SBN- 350  
T.F. B7.1.2

Subject: Revised Response to RAI 410.25; (Auxiliary Systems Branch)

We are again revising our response to RAI 410.25 and the corresponding  
FSAR Section 9.2.5.3c per discussions with the Auxiliary Systems Branch  
Reviewer (Mr. Raj Anand).

**TURBINE PUMP** PERFORMANCE  
2 STAGE 3000 RPM  
892 RPM  
 CURVE NO. 700-51

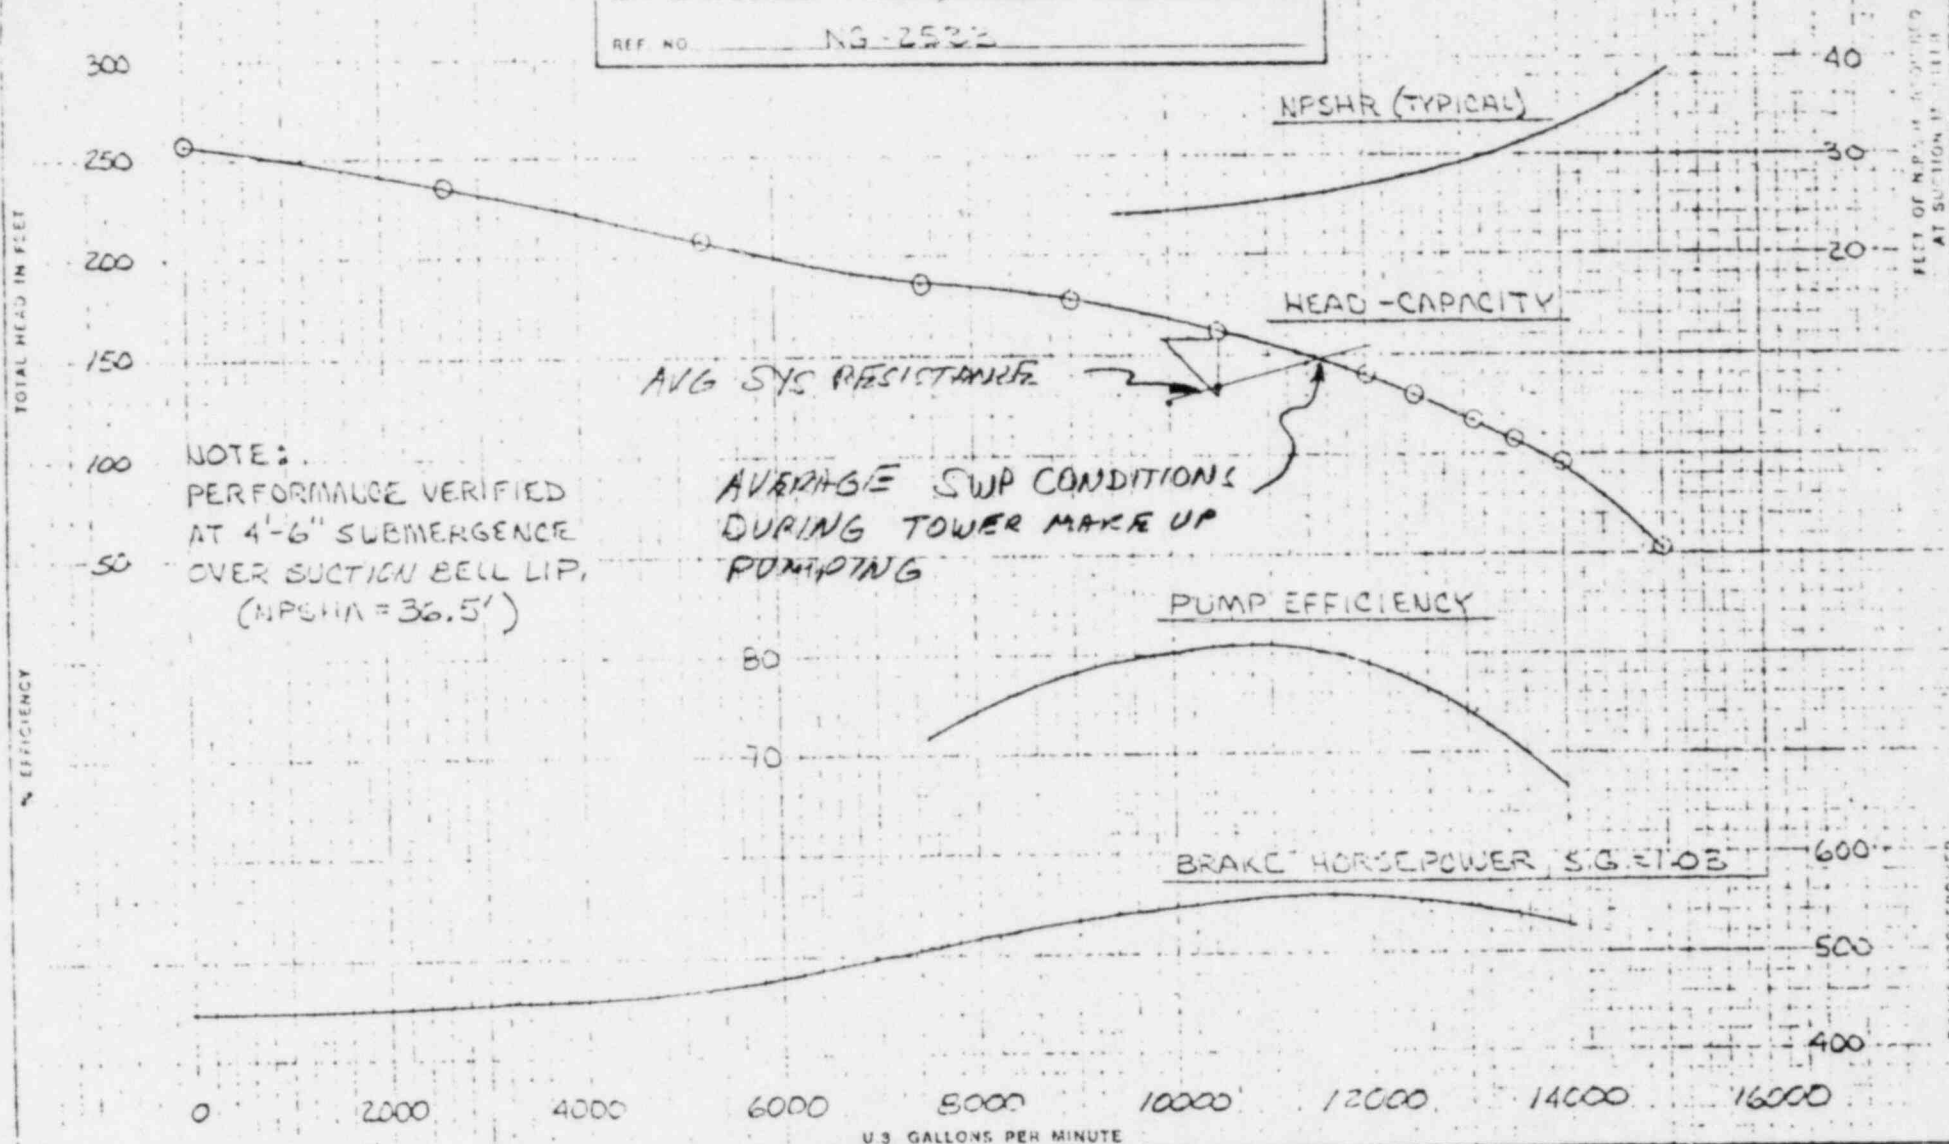
Sufficient tower make-up water is stored in the tower basin for seven days of operation during accident conditions. Following the seven day period and assuming city water is not available, ~~any one~~ of the four service water pumps that are installed in each plant unit may be used to transfer make-up water from the pump house bay to the cooling tower basin. In the unlikely event that water at 80°F or less is not available from the intake tunnel, an event that is only possible if a large seismic disturbance occurs when the tunnel flows are reversed during heat treatment operations, a portable pumping system is used to provide the make-up water. Assuming the in-take tunnel is restricted due to a seismic occurrence, seepage through the tunnel blockage of 300 GPM (after 7 days) would satisfy tower make-up requirements in accordance with Regulatory Guide 1.27.

The safety grade service water system can conveniently be used to transfer pump house water to the tower basin. After one of the service water pumps (SWP) is started the cooling tower pump (CTP), which is operating in parallel with the SWP, is tripped. Then, service water flows through the primary component coolers and the diesel generator coolers before it is discharged through the tower sprays into the basin. The service water flow rate at the 80°F temperature is sufficient to remove the accident condition heat from the coolers. Near the completion of the make-up pumping cycle when either the tower basin becomes full or the pump house water level reaches minimum, one of the CTPs must be returned to service before the SWP is tripped. Except during the periodic tunnel heat treating operation, the service water pump house bays are connected to the intake tunnel transition structure, which at low tide contains 750,000 gallons above the level required for pump NPSH. Sixty-five minutes of service water system pumping on a forty-one hour interval is required to transfer the pump house water to the tower basin. With extended tower operation the plant cooling load will decrease, the tower make-up requirements will decrease, and because the 300 GPM tunnel leakage will exceed the make-up requirements, the tower basin will become filled. After basin filling, the time interval between service water make-up cycles can be extended.
